## **RFQ#21-28 - ADDENDUM #3**

### **Waterloo City Hall 2nd Floor Office Space Renovation**

**ADDENDUM ISSUE DATE: August 8, 2021**

Subject: **Addendum No. 03**

1 DEMO/PARTITION PLAN  
A1 SCALE: 1/8"=1'-0"

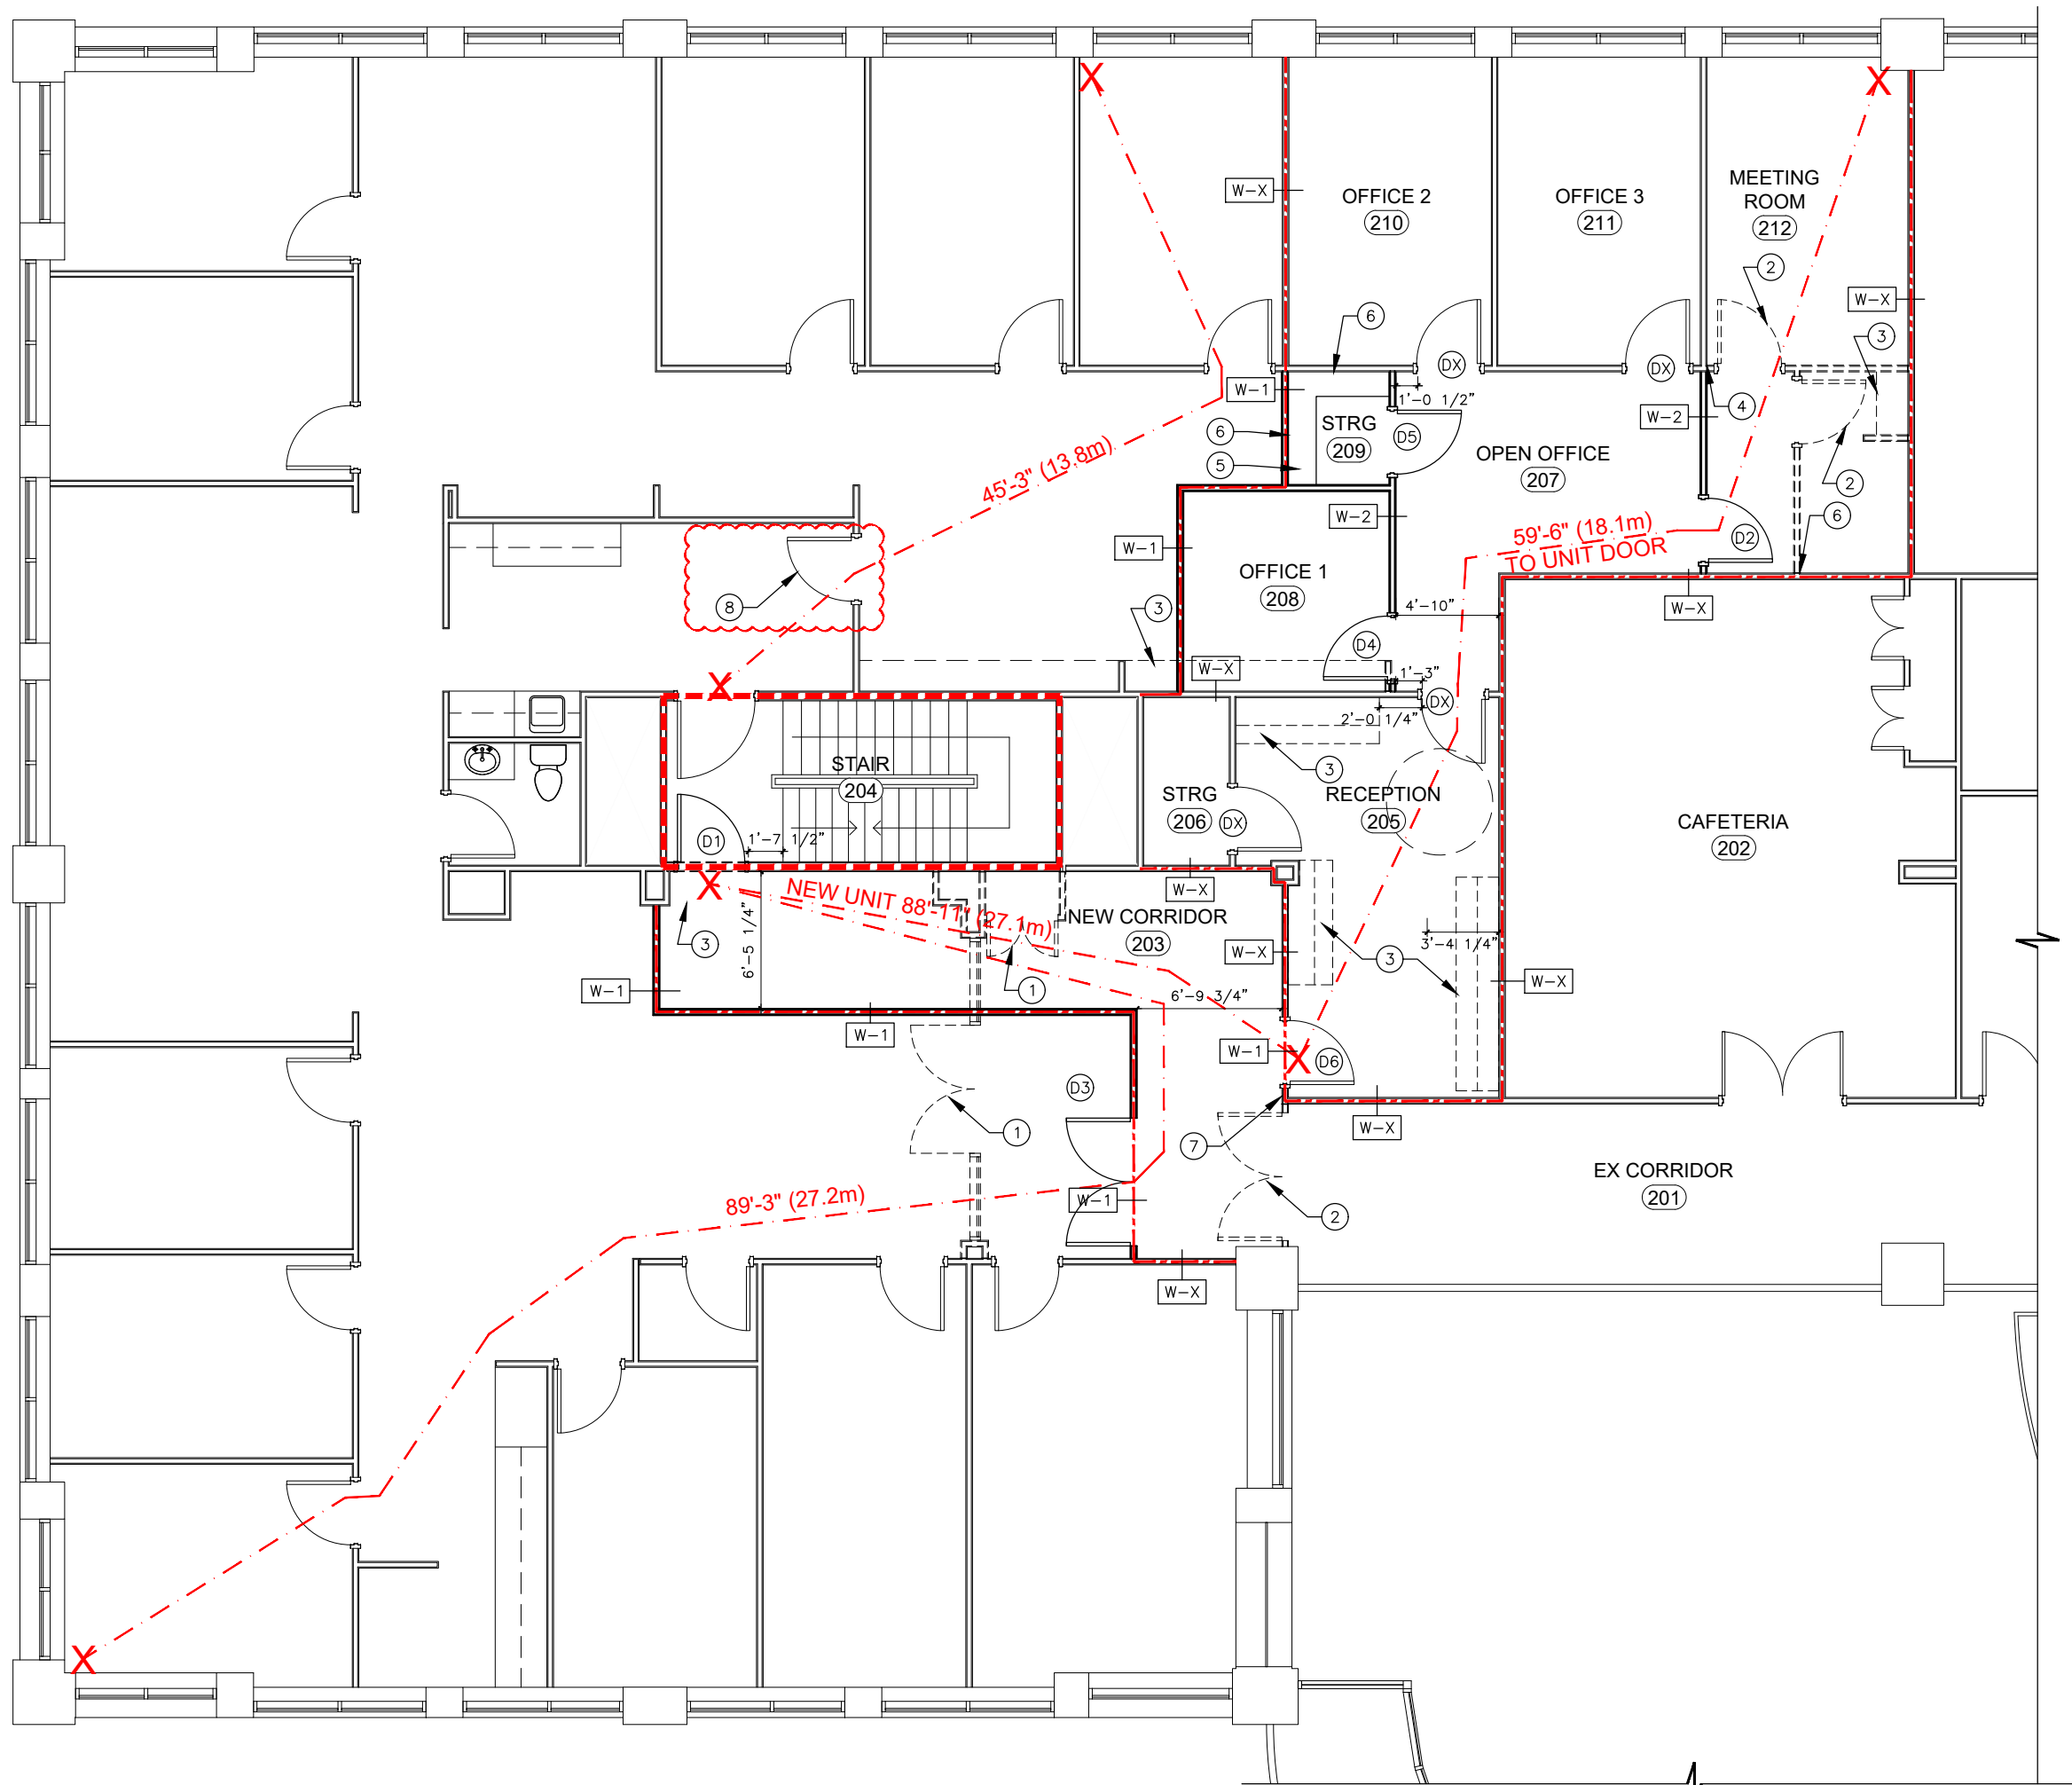
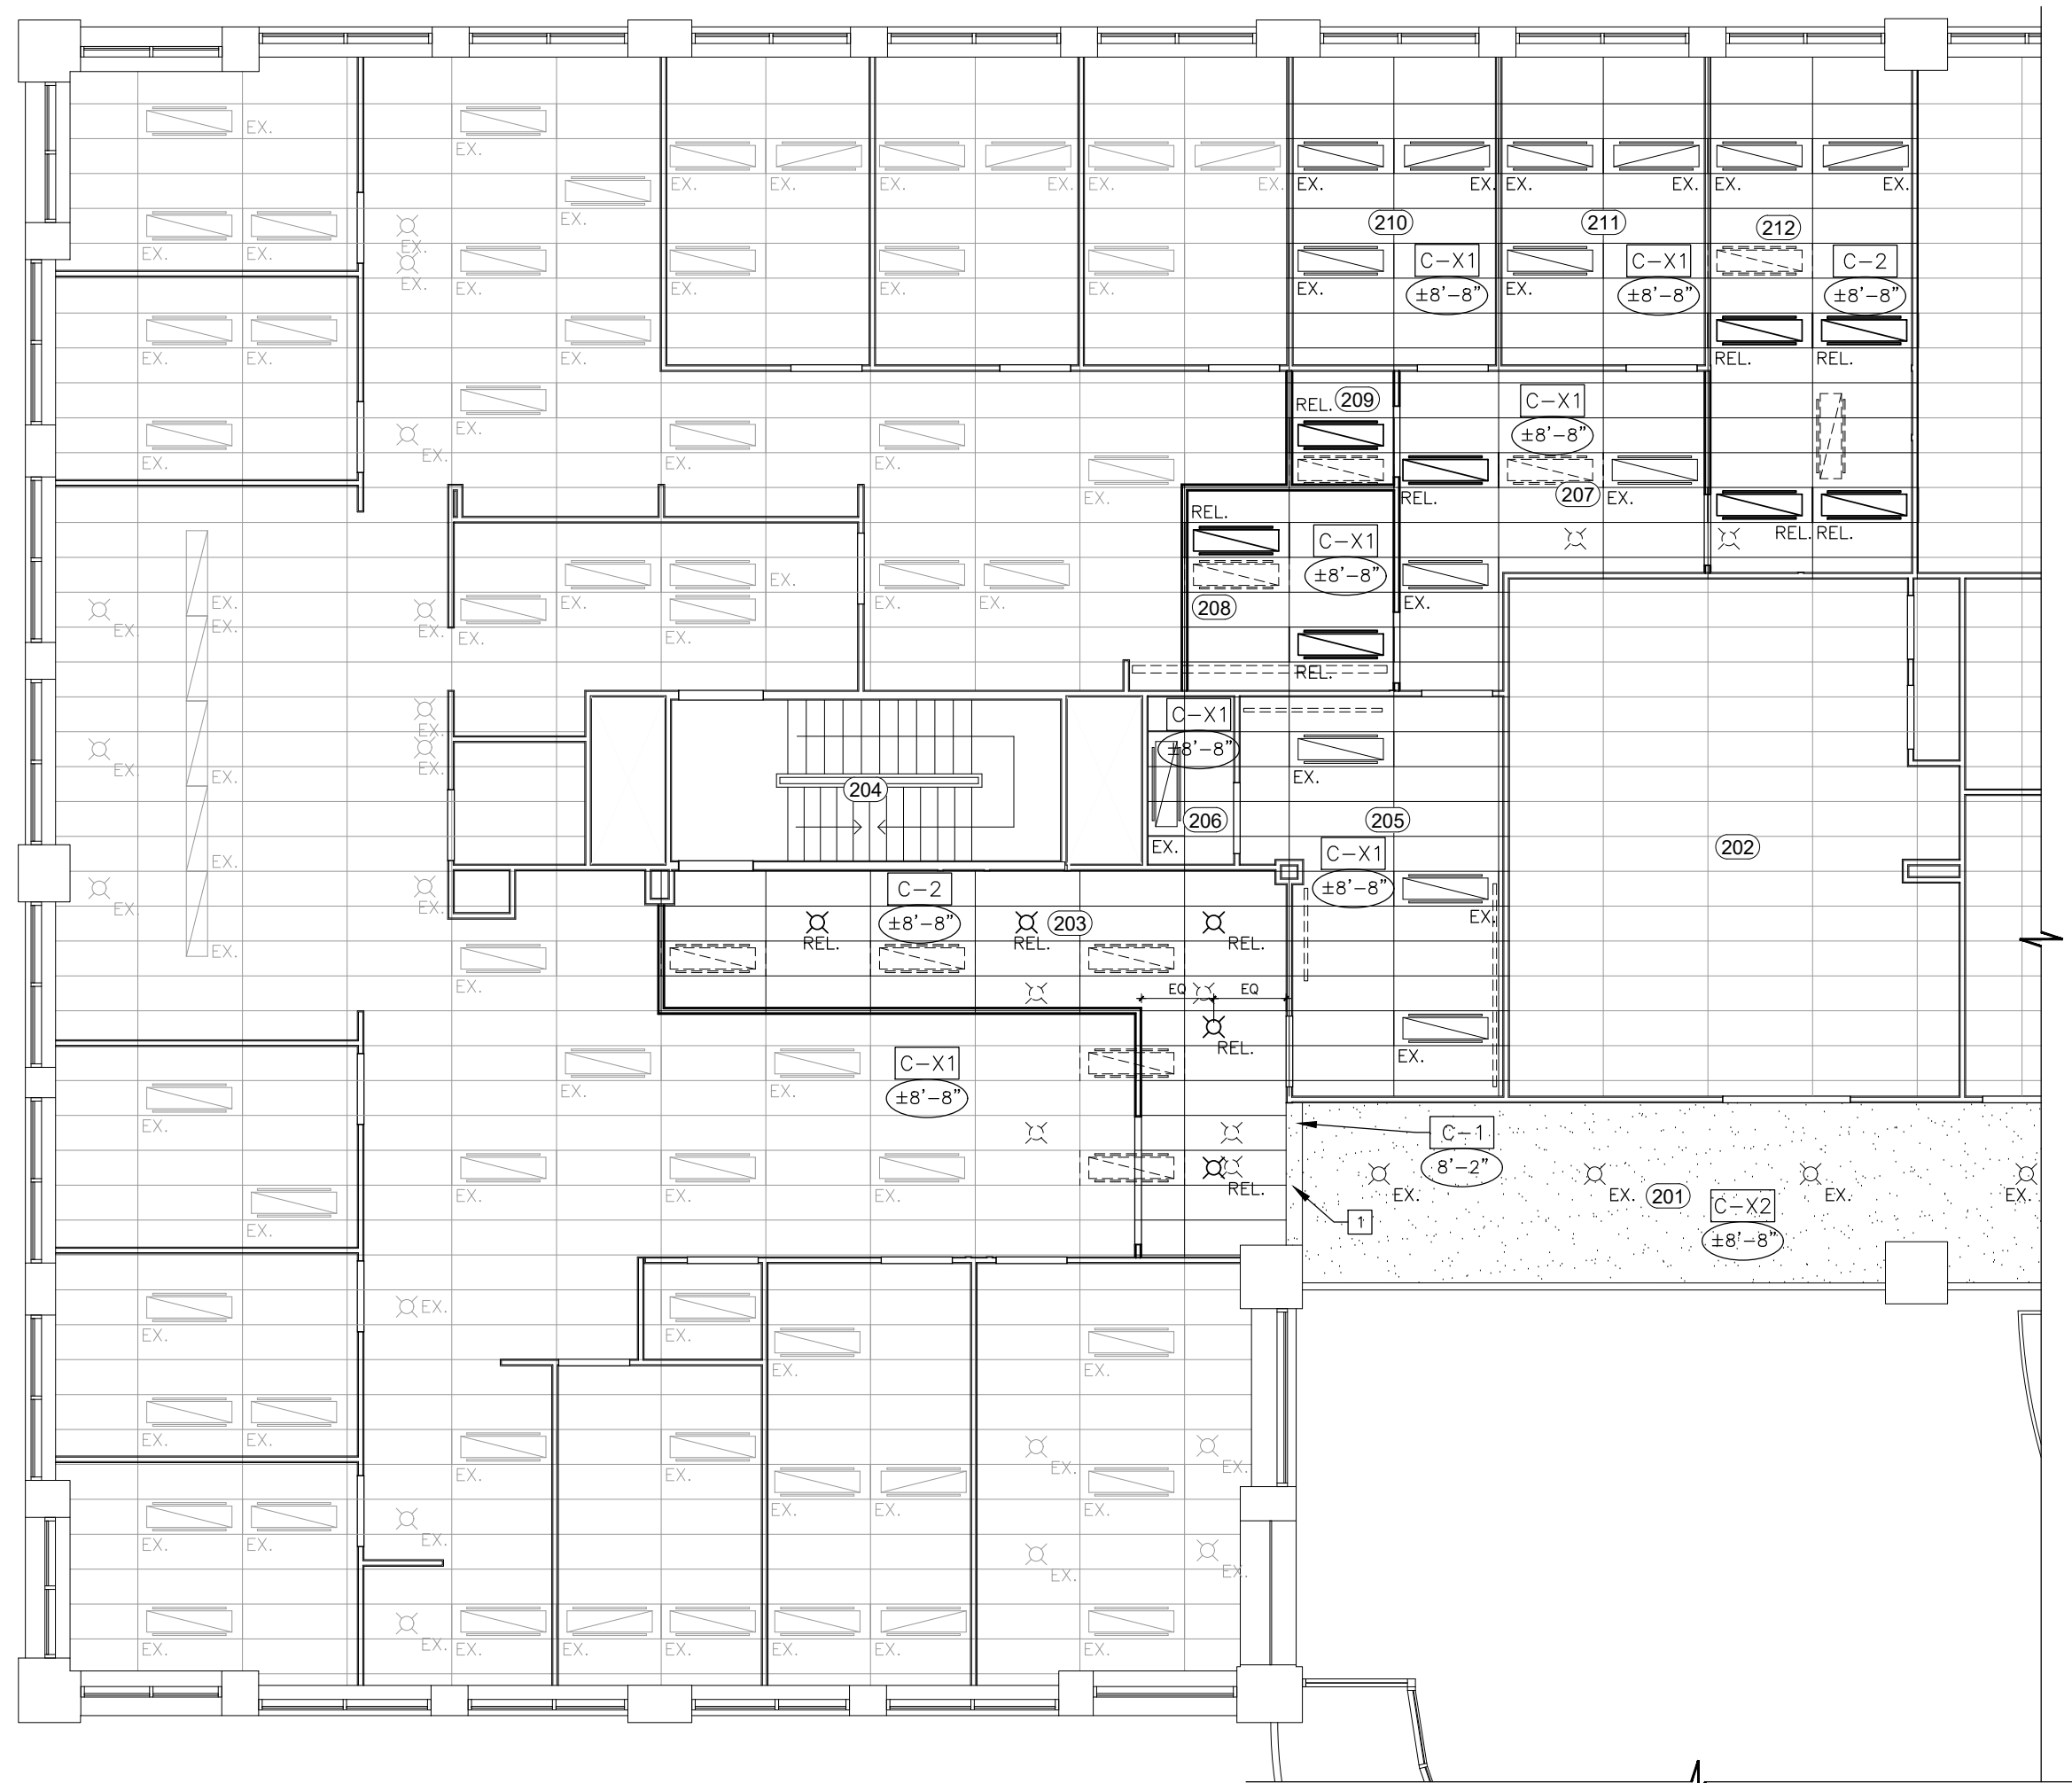
3. New Door D2 complete with frame in Meeting Room 212 to be removed from bid price. Remove and relocate existing Kitchen door complete with frame and associated hardware from adjacent suite to Meeting Room 212. Refer to attached revised drawings A1 for location of door to be relocated. Location of door in Meeting Room 212 to remain as shown on Drawing 1/A1. Repaint relocated door and frame and provide new floor stop. Remove existing door stop in Kitchen and patch floor. Patch and make good walls, floor, base, and ceiling where Kitchen door was removed. Paint walls to match existing. At start of project and prior to removing and relocating Kitchen door and frame, Contractor to verify relocated Kitchen door will have a clear width not less than 810 mm wide per DE77 in Table 11.5.1.1.D/E – 3.8.3.3.(1) in the Ontario Building Code. If width does not meet this requirement, notify the Owner and Architect immediately. Refer to A1, prepared by IBI Group and Elemental, Issued for Addendum #3, dated 04 Aug 2021 for revisions to door schedule and drawings note.

4. Glazing in Door Type A to be located within 900 mm of the Floor (refer to attached approved building permit drawings and revised Architectural Drawings A1, dated 04 Aug 2021). Provide shop drawings.

7. Refer to A1, prepared by IBI Group and Elemental, Issued for Addendum #3, dated 04 Aug 2021 for revisions to General note. "All interior wall and ceiling finishes shall have a maximum flame spread rating of 150, tested in accordance with CAN/ULC-S102 as per OBC 3.1.12. and 3.1.13."

①2 RELOCATED EXISTING KITCHEN DOOR, REPAINT & PROVIDE FLOOR STOP.
